# UNITED STATES PATENT AND TRADEMARK OFFICE

APPLICATION NO.	FILING DATE	FIRST NAMED INVENTOR	ATTORNEY DOCKET NO.	CONFIRMATION NO.
09/555,899	07/20/2000	STEFAN BRAUCHLE	225/48888	8921

# Office Action Summary

## **DETAILED ACTION**

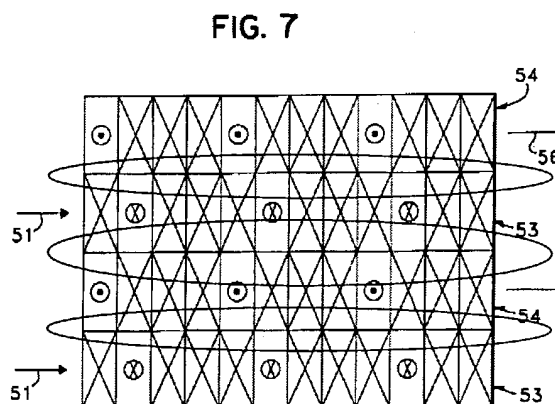
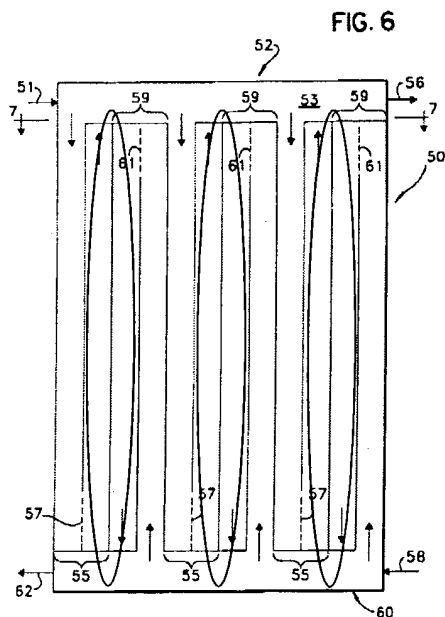
a plurality of reaction chambers (59) with catalyst (col. 3, lines 10-14) and a plurality of cooling chambers (55) (col. 9, lines 10-14) wherein said chambers are formed between successive plates and defining at least two stages in a plate stack (fig. 6 and col. 8, line 58- col. 9, line 14);

wherein said plates have openings that form inlet or outlet channels for the reaction chambers (61) and the cooling chambers (51);

wherein the reaction chambers (59) are each connected exclusively to inlet (58) and outlet (62) channels for the gas flow;

wherein the cooling chambers (55) are each connected exclusively to inlet (51) and outlet (56) channels for the coolant flow;

separating plates (shown as 22 in figure 2, but not numbered in figures 6 and 7, the separating plates are circled in the figures of Romatier below) arranged between at least two successive stages; and

a first apparatus (58) for supply gas to a first stage.
